CITY OF ONTARIO DEVELOPMENT ADVISORY BOARD

AGENDA

August 21, 2017

B. ENVIRONMENTAL ASSESSMENT DEVELOPMENT PLAN AND TENTATIVE PARCEL MAP REVIEW FOR FILE NOS. PDEV16-002 AND PMTT16-001/PM

Figure 1
 PDS#17-2019-0017,002
 Engineer: Miguel Solomero
 Reviewed by: Jimmy Chang, Fiber Team 8-14-17

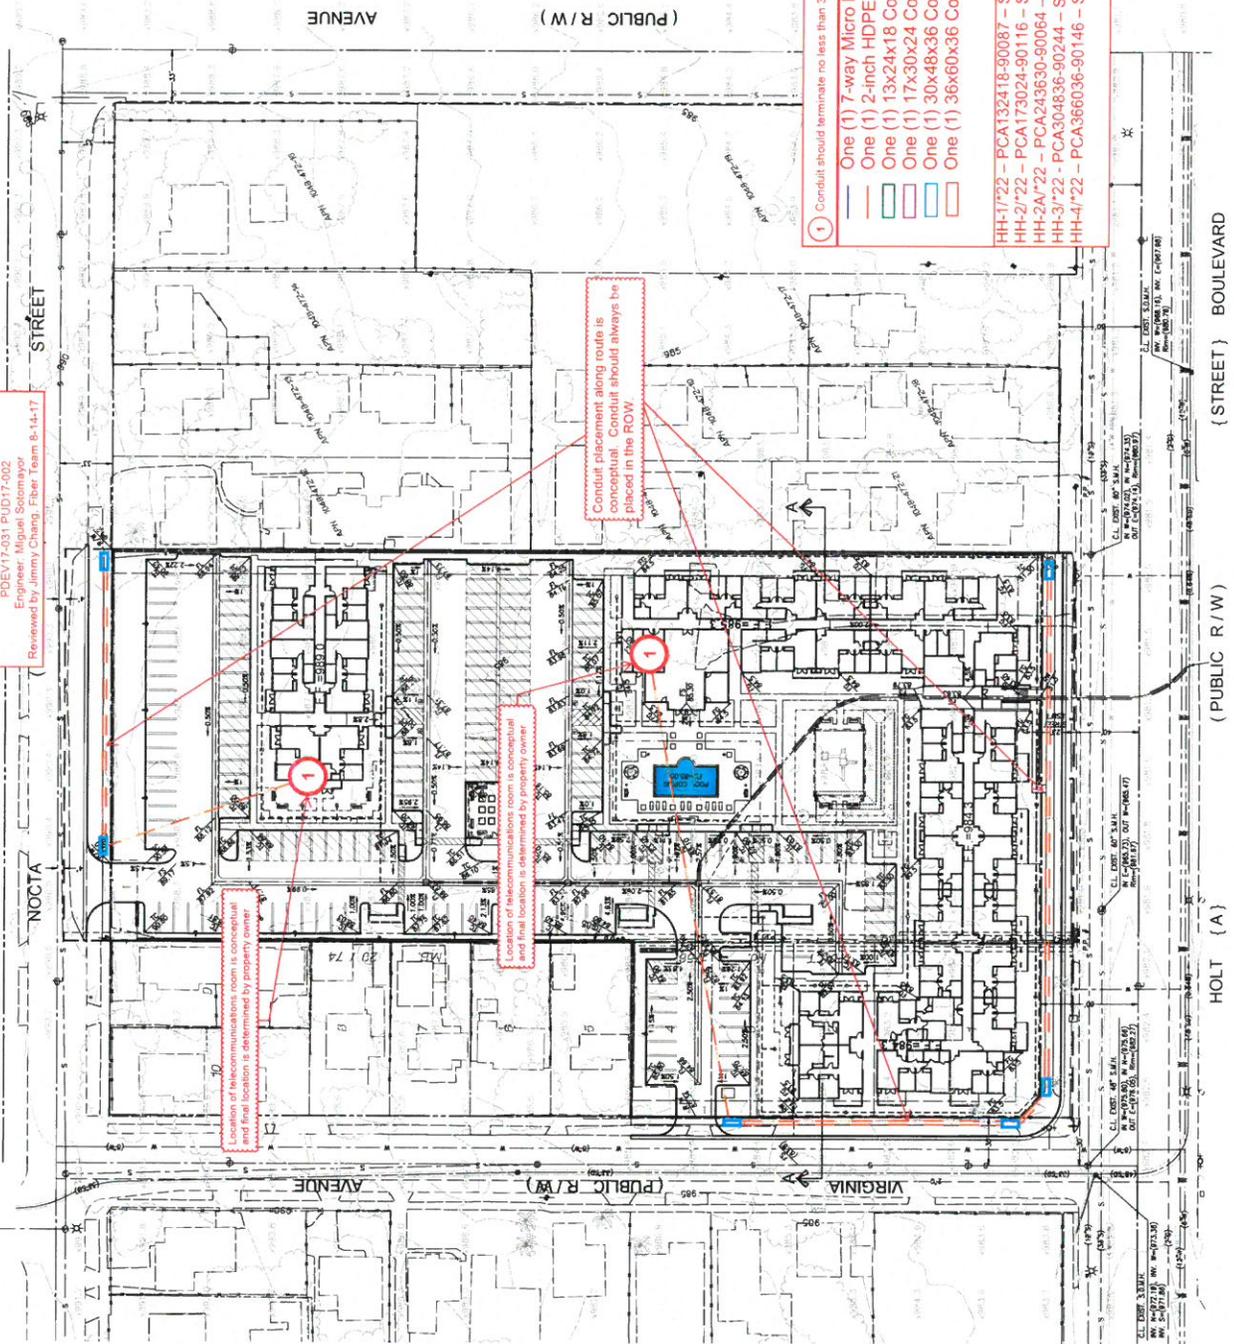
- ① Conduit should terminate no less than 3 inches above the finished floor in the telecommunications room against the wall.
- One (1) 7-way Micro Duct (Duraline) - 16mm Tubes or Equivalent
 - One (1) 2-inch HDPE SDR-11 Smoothwall Orange Conduit
 - One (1) 13x24x18 Composite Polymer Concrete Hand Hole (HH1)
 - One (1) 17x30x24 Composite Polymer Concrete Hand Hole (HH2)
 - One (1) 30x48x36 Composite Polymer Concrete Hand Hole (HH3)
 - One (1) 36x60x36 Composite Polymer Concrete Hand Hole (HH4)
- HH-1/22 - PCA132418-90087 - Size 13" x 24" x 18"
 HH-2/22 - PCA173024-90116 - Size 17" x 30" x 24"
 HH-3/22 - PCA243630-90064 - Size 24" x 36" x 30"
 HH-4/22 - PCA304836-90244 - Size 30" x 48" x 36"
 HH-4/22 - PCA366036-90146 - Size 36" x 60" x 36"

Figure 1
 PDSV17-2016-0017,002
 Engineer: Miguel Solomero
 Reviewed by: Jimmy Chang, Fiber Team 8-14-17

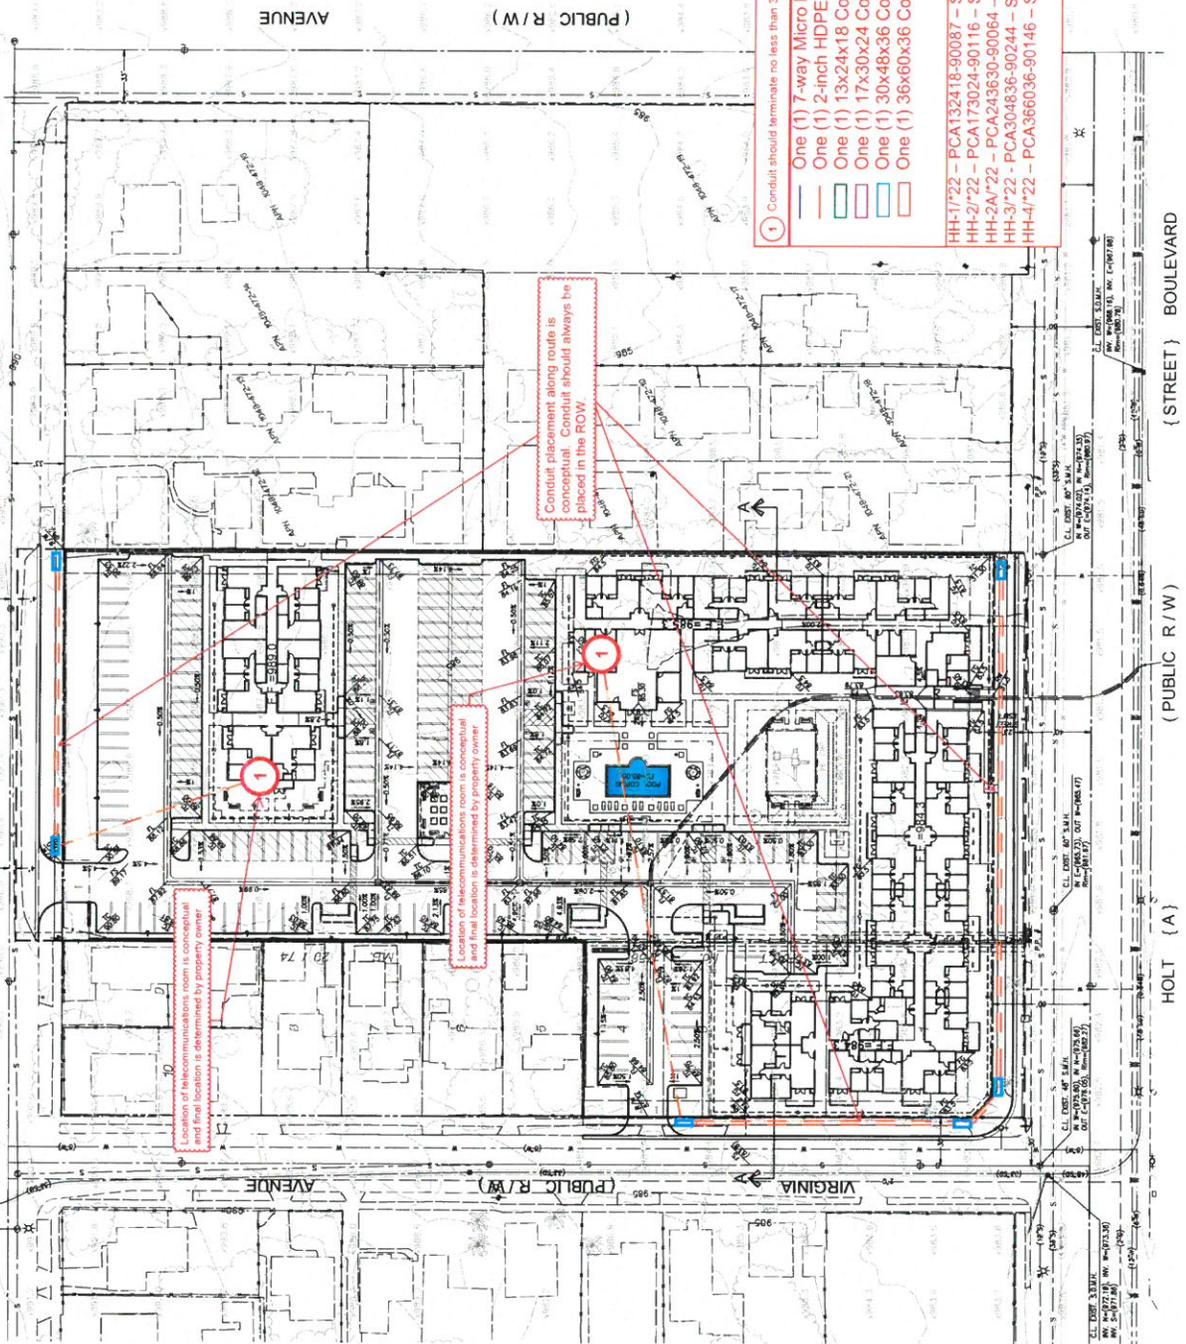
- ① Conduit should terminate no less than 3 inches above the finished floor in the telecommunications room against the wall.
- One (1) 7-way Micro Duct (Duraline) - 16mm Tubes or Equivalent
 - One (1) 2-inch HDPE SDR-11 Smoothwall Orange Conduit
 - One (1) 13x24x18 Composite Polymer Concrete Hand Hole (HH1)
 - One (1) 17x30x24 Composite Polymer Concrete Hand Hole (HH2)
 - One (1) 30x48x36 Composite Polymer Concrete Hand Hole (HH3)
 - One (1) 36x60x36 Composite Polymer Concrete Hand Hole (HH4)
- HH-1/22 - PCA132418-90087 - Size 13" x 24" x 18"
 HH-2/22 - PCA173024-90116 - Size 17" x 30" x 24"
 HH-3/22 - PCA243630-90064 - Size 24" x 36" x 30"
 HH-4/22 - PCA304836-90244 - Size 30" x 48" x 36"
 HH-4/22 - PCA366036-90146 - Size 36" x 60" x 36"
